M4 Junction 48 and A4138

WelTAG Appraisal (Stage 3) – The Transport Case

M4 Junction 48 and A4138 Improvement Works

Stage 1 Road Safety Audit Response Report

Figure 4-1 Scheme Detailed Design

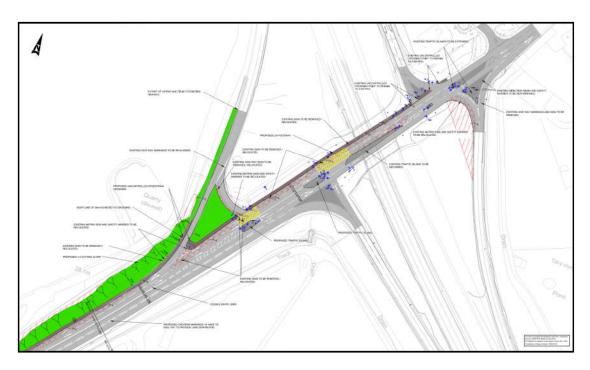
- The initial proposal included the provision of a physical island between motorists joining the A4138 from the M4 westbound off-slip. This aspect was revised to the provision of hatched markings so as to remove the need to acquire third party land at this location. The land would have been required in order to provide the required lane width;

- Detailed design of the traffic signals has resulted in minor amendments to stop line and traffic island positions and the removal of the A4138 (northbound carriageway) advanced stop line immediately adjacent of the eastbound on-slip;

- A free flow merge was originally proposed on the westbound M4 J48 entry slip, however, a detailed review of the existing levels determined standard gradients could not be achieved without full reconstruction of this area. On the grounds of the level of disruption this would cause to the travelling public being disproportionate to the benefit, the decision was made to revert to the existing give way layout;

- The existing width of the A4138 is slightly less than the DMRB standard. Through discussions with CCC it was agreed that there was no material benefit of widening the southern section of the A4138 by less than 0.5m to achieve the required standard due to the cost and disruption that would result. An appropriate tie in location was identified as a result;

- The earthwork design along the realigned westbound entry slip road has been amended to provide a wider highway verge to improve visibility sight lines to the uncontrolled pedestrian crossing facility which links the northern footway network; and

- The Road Safety Audit (RSA) identified minor issues which are proposed to be addressed by the addition of some louvres, signal aspect amendments and additional vegetation clearance to enhance visibility. Full details of the RSA are provided in **Appendix B**.
